**FEASIBILITY REPORT  
A20 DEVELOPMENT SITES-  
ACCESS ASSESSMENT**

## A20 Development Sites – Access Assessment

CO04300616/R/001 Revision 0

# Stage 1 Road Safety Audit A20 Maidstone Road, Hothfield, Ashford: Access Assessment

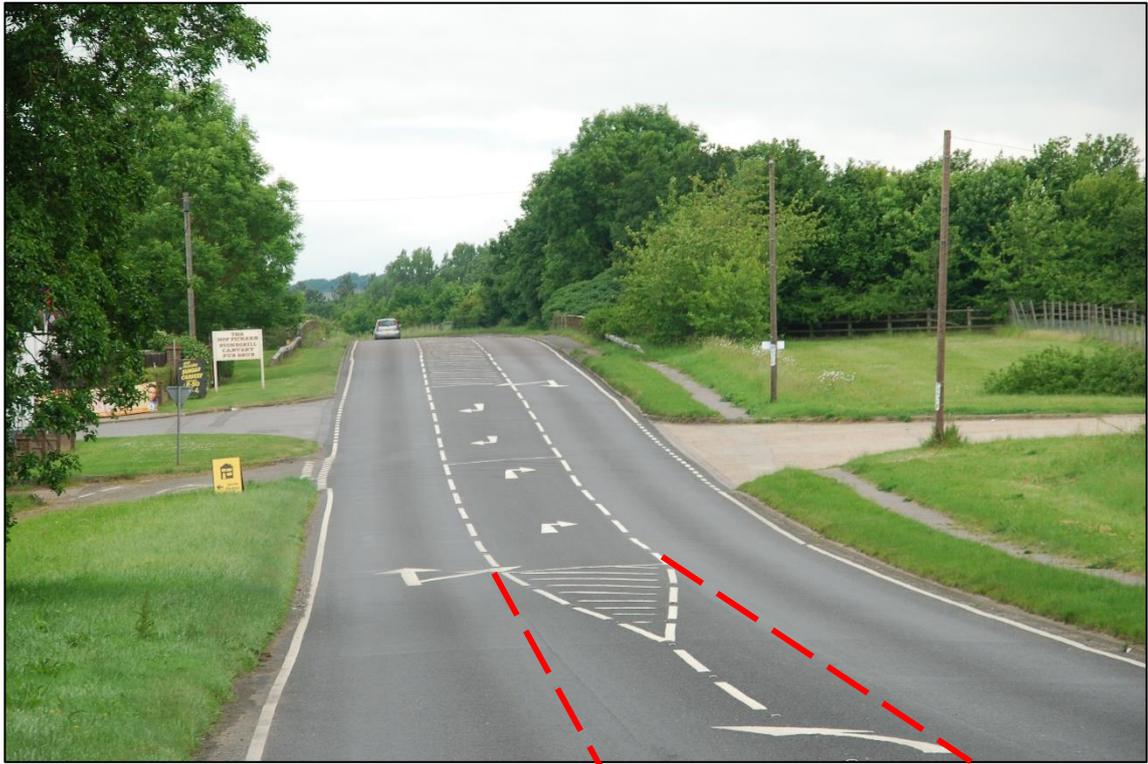
The angle of approach along the access road towards the A20 may make it difficult for left turning larger vehicles to negotiate the junction without impinging into the ghost island. This may increase the risk of offset head-on collisions between vehicles exiting the access road and those turning right from the A20 towards the development.

Swept path analysis should be used to demonstrate that all vehicles that may require access to the development can negotiate the junction without undue difficulty.

The Design Team considers that the junction layout shown is a standard skew junction arrangement as recommended in TD 42/95 – Figure 7/15. The left turn arrangement from the major road is not intended to be a slip road.

**Location:** L – A20 ghost island.

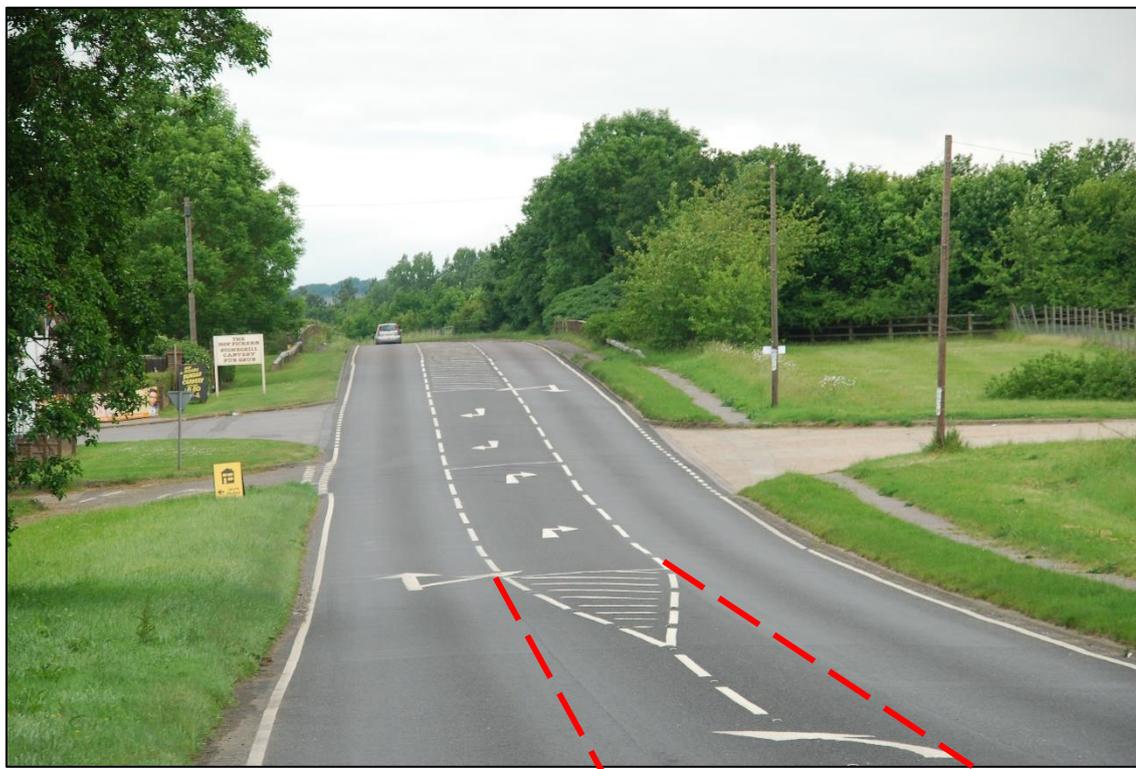
The proposed ghost island for site 2 will, when implemented, add to a sequence of existing ghost islands along this stretch of the A20. The close spacing of the ghost islands may present some drivers with navigational difficulties, even if following Satnav instructions. This may increase the risk of shunts or side swipe collisions with following vehicles if drivers start to manoeuvre, realise that they have the wrong junction and move off again.

Use a combination of road markings and local destination signing to give drivers the best chance of identifying the correct junction for their intended destination.

Para. No.	Issues Identified and Their Recommendations
4.4.2	<p>Risk of the extended ghost island layout along the A20 providing an opportunity to overtake slower moving traffic for impatient drivers.</p> <p>Break up the clear run along the sequence of ghost islands with traffic islands to deter overtaking.</p>
<b>Design Team Project Manager Response</b>	
<p>The Design team agrees with the Audit Team. The provision of traffic islands should be considered at the next stage of the design.</p>

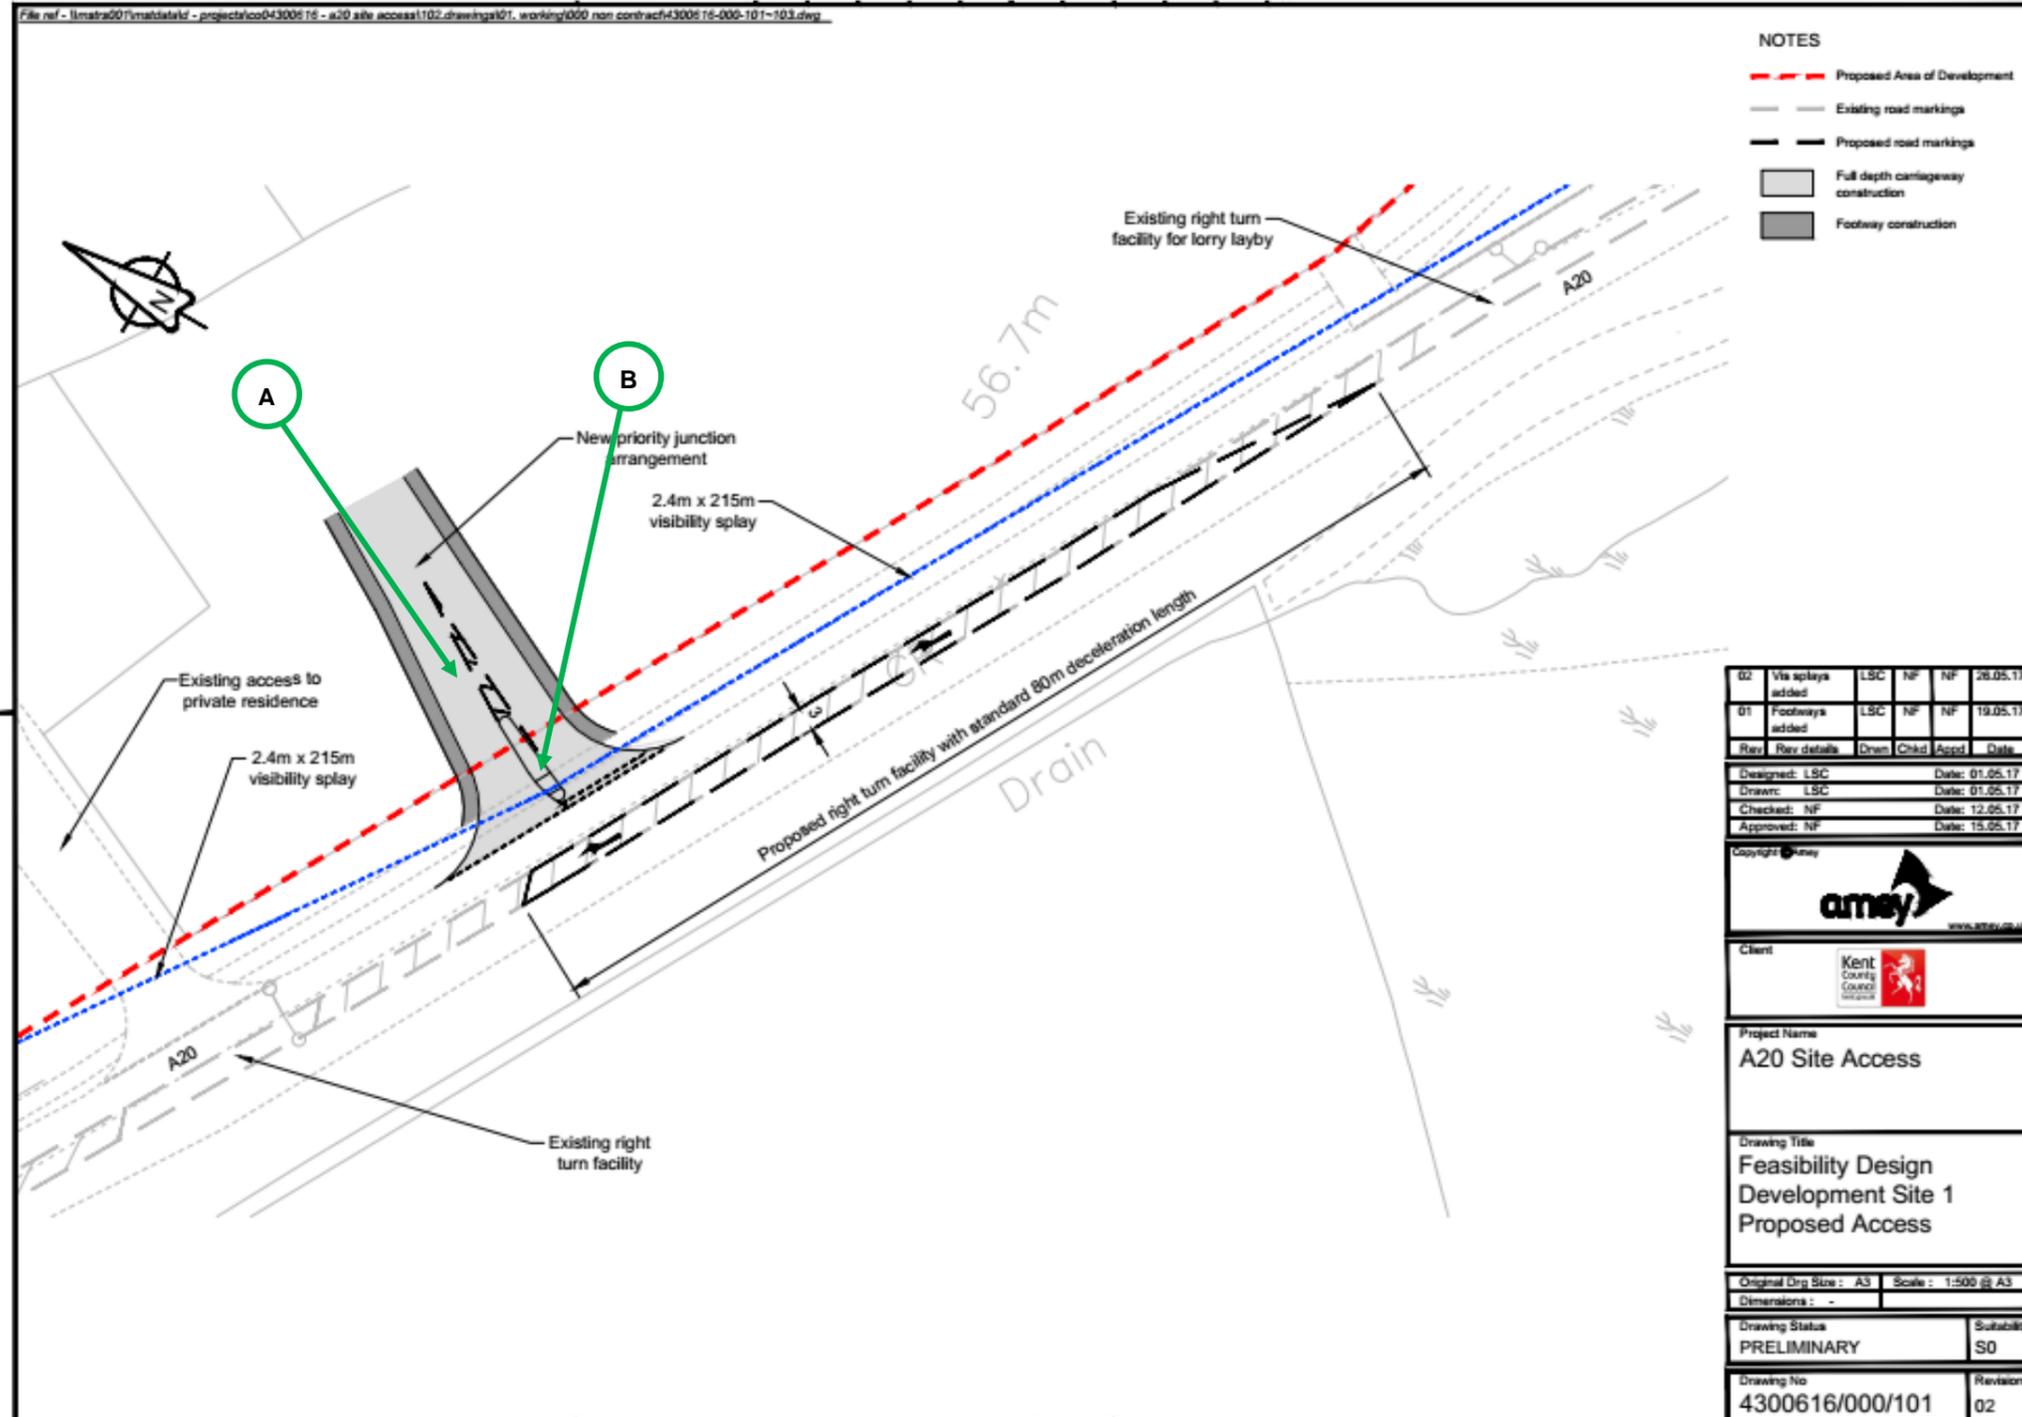
The visibility splay to the right at the proposed access coincides with existing vegetative growth. At this stage in the design process, intentions with respect to existing vegetation are not known. Failure to provide a robust visibility splay at the junction may, however, increase the risk of 'failed to give' way side impact collisions.

Ensure that visibility splays are clear of obstacles. Any planting or retained vegetation should allow growth to take place without frequent cutting back being required to maintain visibility.

Para. No.	Issues Identified and Their Recommendations
4.1.1	<p>Vegetation may constrain visibility to the right.</p> <p>Ensure that visibility splays are clear of obstacles. Any planting or retained vegetation should allow growth to take place without frequent cutting back being required to maintain visibility.</p>
<b>Design Team Project Manager Response</b>	
<p>The Design Team accepts that, with the junction in its current location, there will be a need for some site clearance in the form of vegetation and potentially tree removal, to ensure that the required visibility splays are achieved. This may have environmental implications that will need to be further investigated at the next stage of the design.</p> <p>The current junction location is dictated by the existing right turn facility which currently serves the lorry layby. If the layby were to be closed, as proposed on Drg. 006, there would be opportunity to move the proposed junction further east which would serve to improve visibility to the right and also remove or greatly reduce the need for vegetation clearance.</p>

Drawing No: 4300616/000/104 Revision: 02

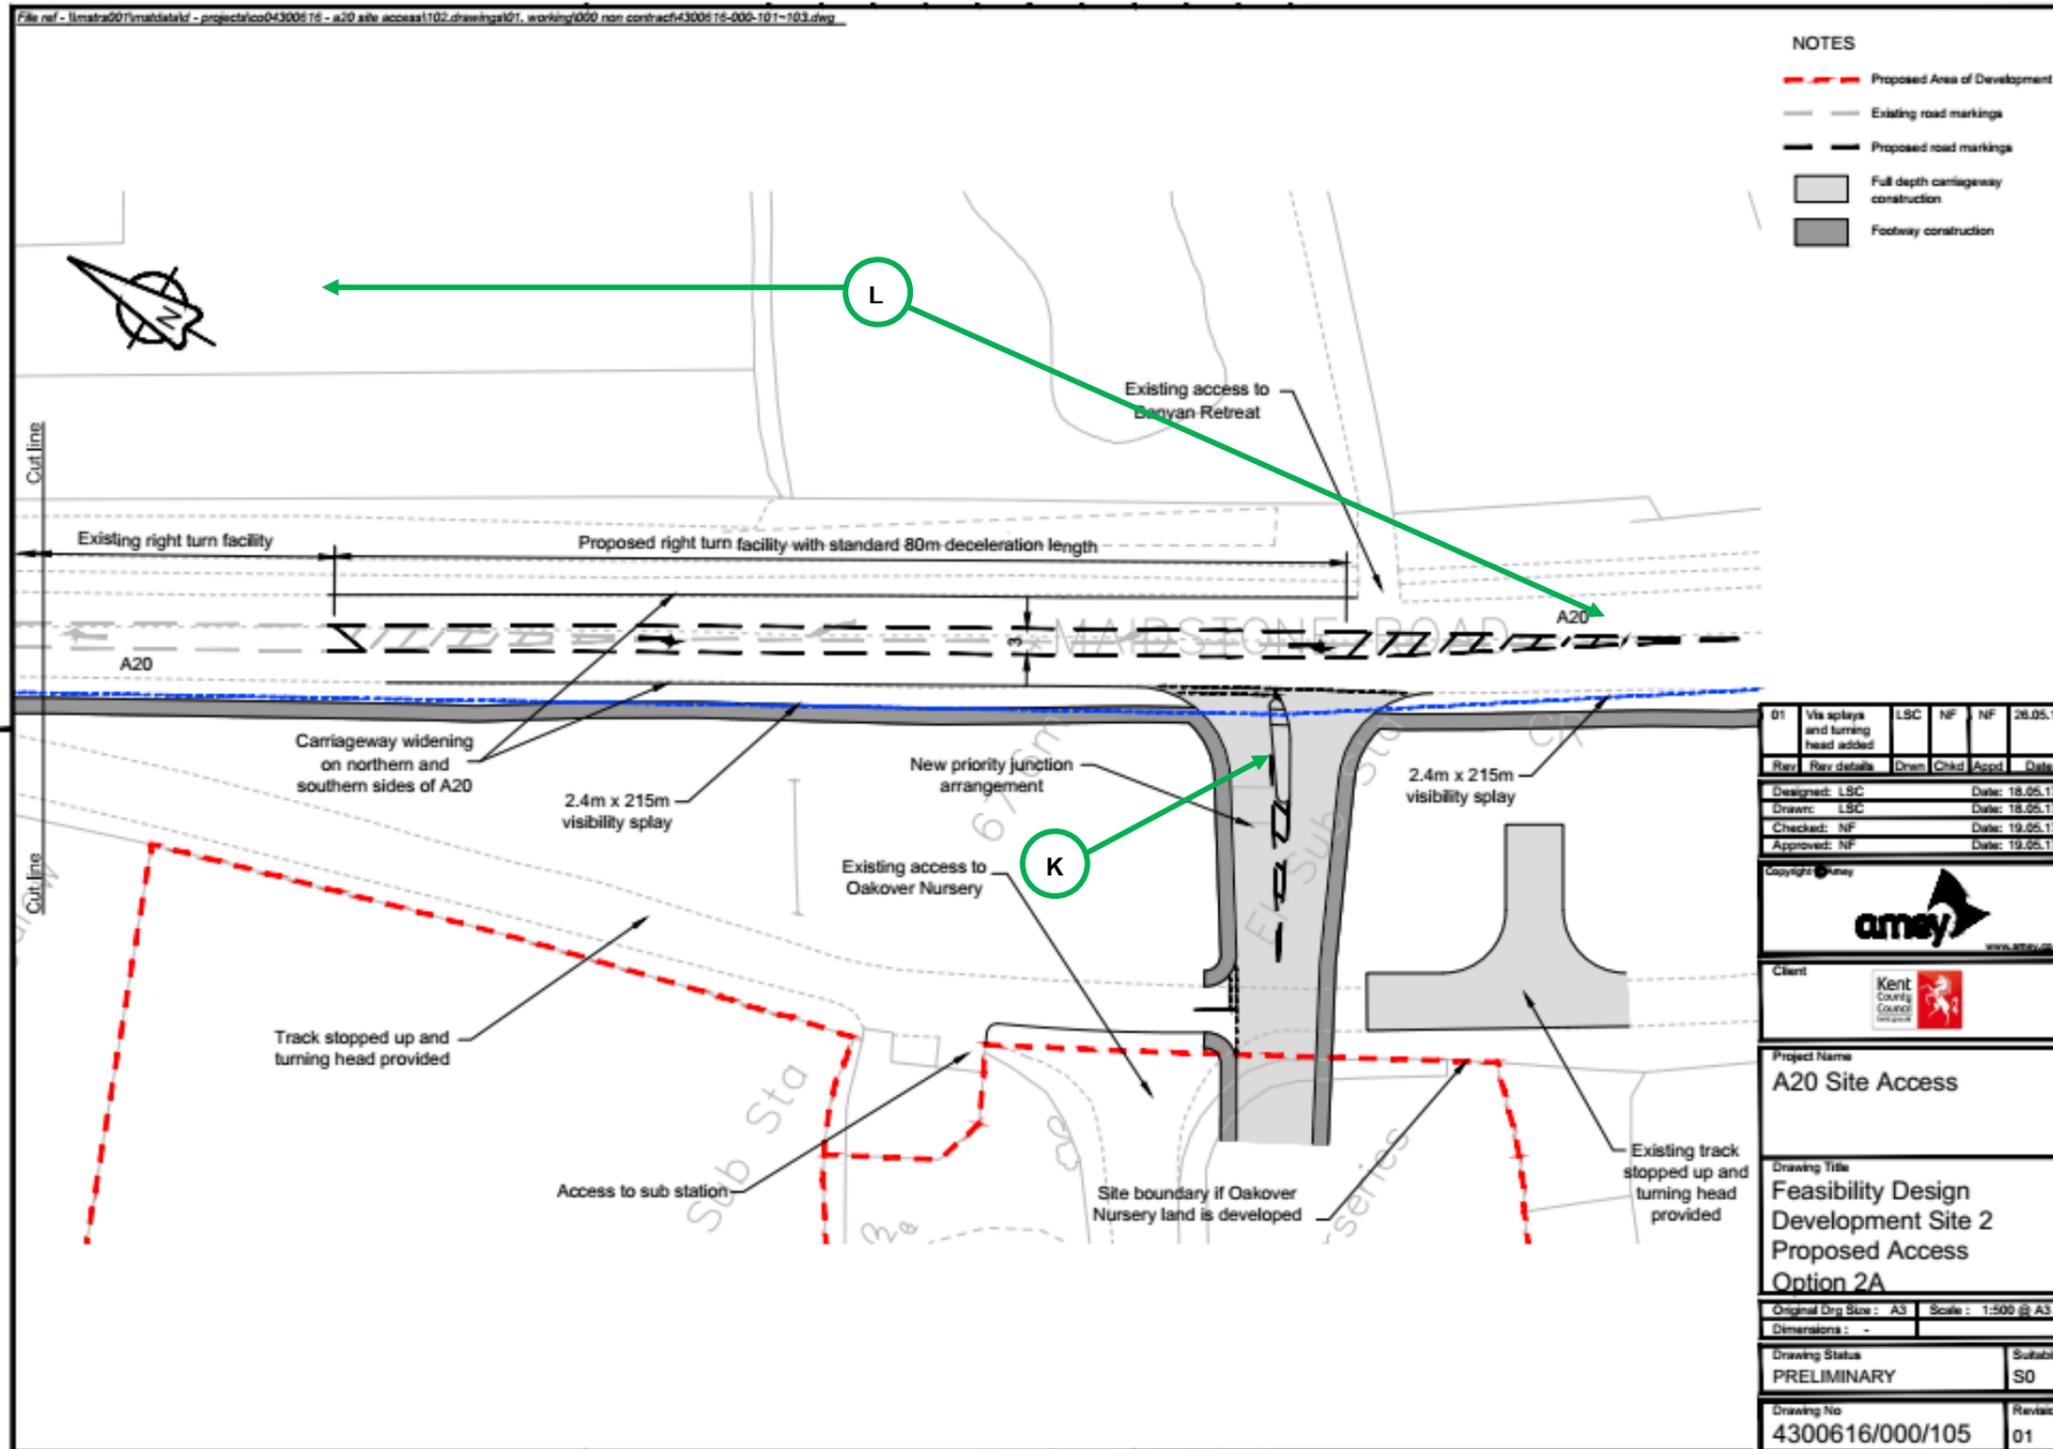
The proposed ghost island for site 3 will, when implemented, add to a sequence of existing ghost islands along this stretch of the A20. The close spacing of the ghost islands may present some drivers with navigational difficulties, even if following Satnav instructions. This may increase the risk of shunts or side swipe collisions with following vehicles if drivers start to manoeuvre, realise that they have the wrong junction and move off again.

Use a combination of road markings and local destination signing to give drivers the best chance of identifying the correct junction for their intended destination.

4.5.2	<p>Risk of the close proximity of a number of accesses, proposed and existing, being confusing for drivers to navigate.</p> <p>Use a combination of road markings and local destination signing to give drivers the best chance of identifying the correct junction for their intended destination.</p>
-------	---
